**National Education Society for Tribal Students**  
(An Autonomous Organization under  
Ministry of Tribal Affairs, Govt. of India)  
Ground Floor, Gate No.3 A, Jeevan Tara Building,  
Parliament Street, New Delhi-110001  
Telephone No. 011-23340280  
वेबसाइट/Website: www.tribal.nic.in  
Email: nests-tribal@tribal.gov.in

**File No: NESTS/Civil/EMRS Order/140/2021-22(Pt.)**

**Sub: Consolidated guidelines on C/o EMRS Buildings – MLP, DPR, Architectural Drawings (Phase-1),  
Specification, Clarification & General Guidelines regarding.**

*[Signature]*  
 (NARENDRA KUMAR)

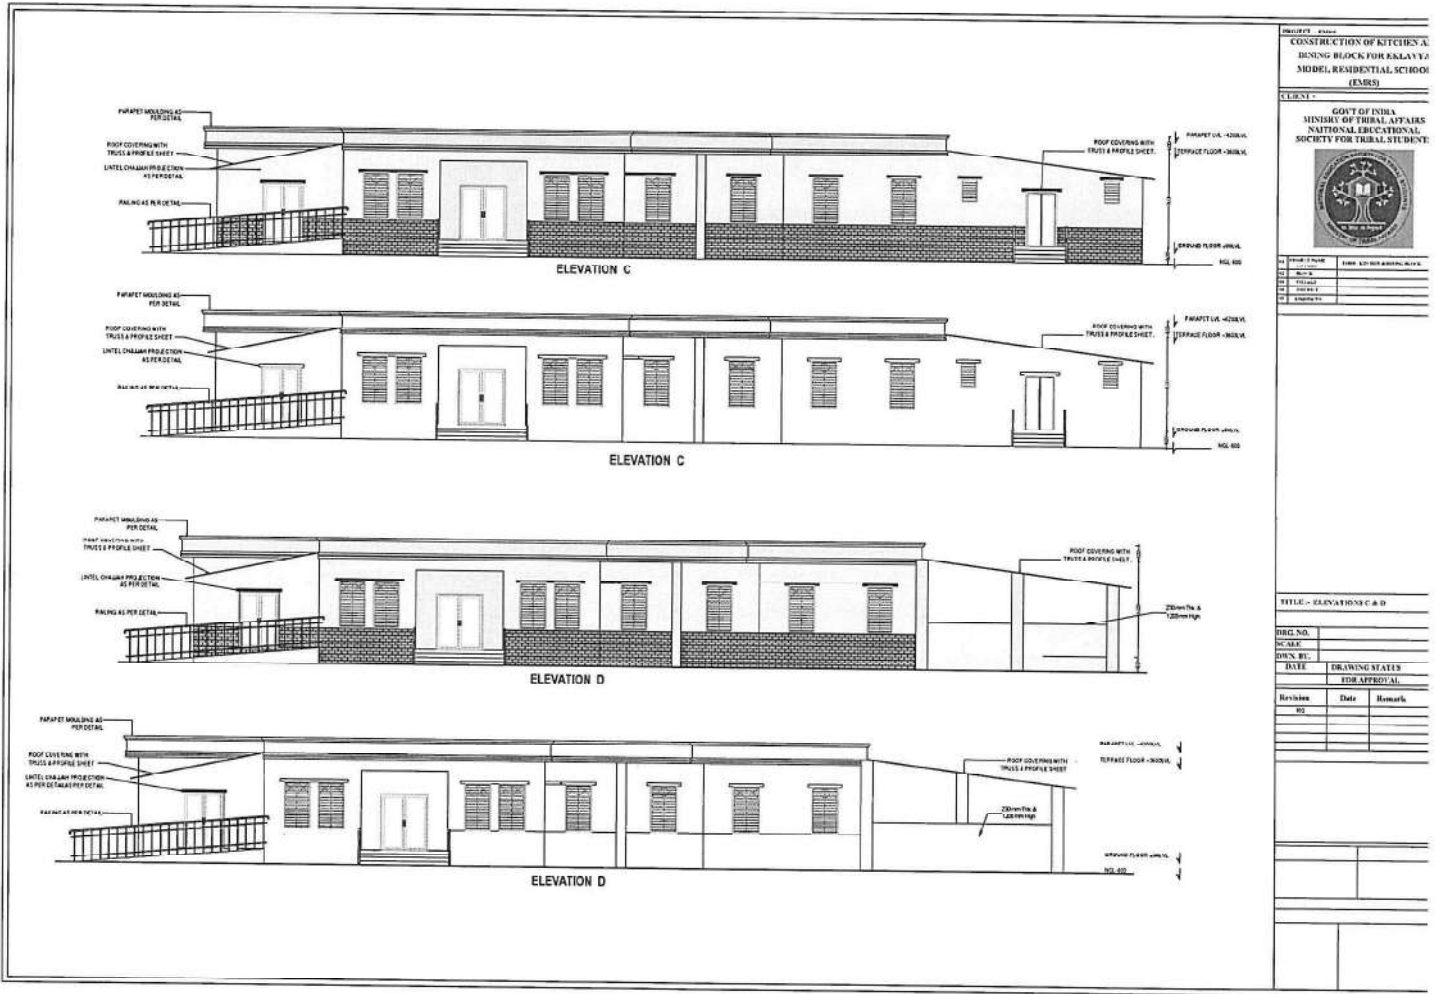
- i. The floor plans of all buildings were retained except toilet blocks of school & hostel buildings.
- ii. In CPWD based drawings, for toilet block, there was a common entry lobby for boys, girls and person with disability, which is not proper from service/safety point of view. Hence Toilet blocks were modified to provide separate entry and to accommodate drinking water facility. The orientation of washroom for differently abled person, boys and girls has also been modified in order to enhance utility with more ease.

- iii. The toilet blocks of hostels were cramped and hence area of bath and WC are enhanced to meet the NBC guidelines and for easy movement of students.

- iv. The rear stair cases of school building are taken upto First Floor only. The front 2 Nos of stair case will be taken upto mumty for restricting undesirable access to terrace.

- v. In school building, one bay at FF was kept void in approved drawing, which has been covered with roof slab to avoid dumping space in between the class rooms and for better aesthetic appearance.

**In respect of earlier approved DPR, where the work has just commenced or about to commence, the necessary modification as per architectural drawings shall be made, particularly toilet blocks of school & hostels.** Wherever, the foundation completed, the internal partition of toilets may be suitability modified to the possible extent.

**The construction agencies are requested to submit the working drawings of all buildings as per updated detailed drawings before commencement of works.**
